PRODUCT CHANGE NOTIFICATION

PCN66266-051818

66266 / 6 PIN GULL WING PROTON RADIATION TOLERANT OPTOCOUPLER, WITH 850 nm LED

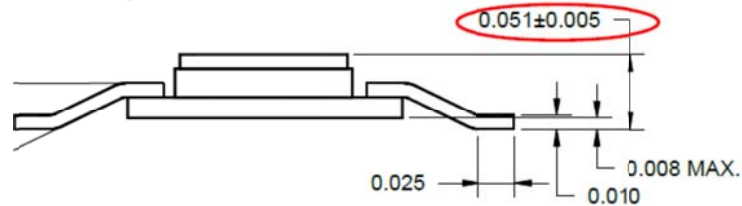
Overall height dimensional change:

From: .046 ± .010 inches [.036" to .056"]

To: .051 ± .005 inches [.046" to .056"]

Overall height increased to improve manufacturability by increasing the headspace for the optical coatings
